Delegated officer report for planning application

Application no. CDN/25/0105

Proposal: Discharge of conditions 2 (specified plans) 3 (specification), 4 (security measures), 5 (CCTV), 6 (Photographic Record) and 7 (archaeological survey) attached to Listed Building Consent referenced 135355/LO/2022

Address: Clayton Old Hall, Ashton New Road, Manchester, M11 4RU

NORTH BOUNDARY FENCE AT SCREW PILE LOCATION

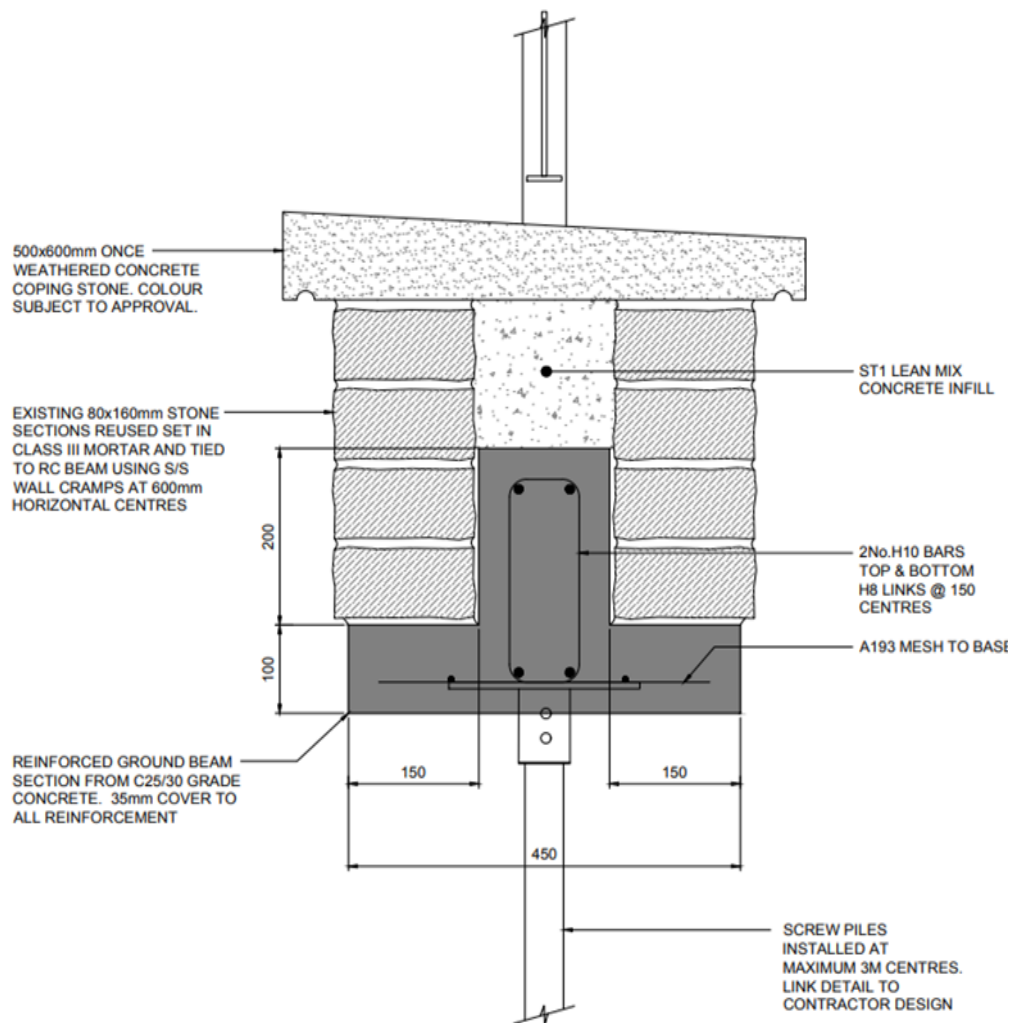
The section drawing shows a concrete coping. Are existing copings in concrete? Other wise we should be asking for natural stone.
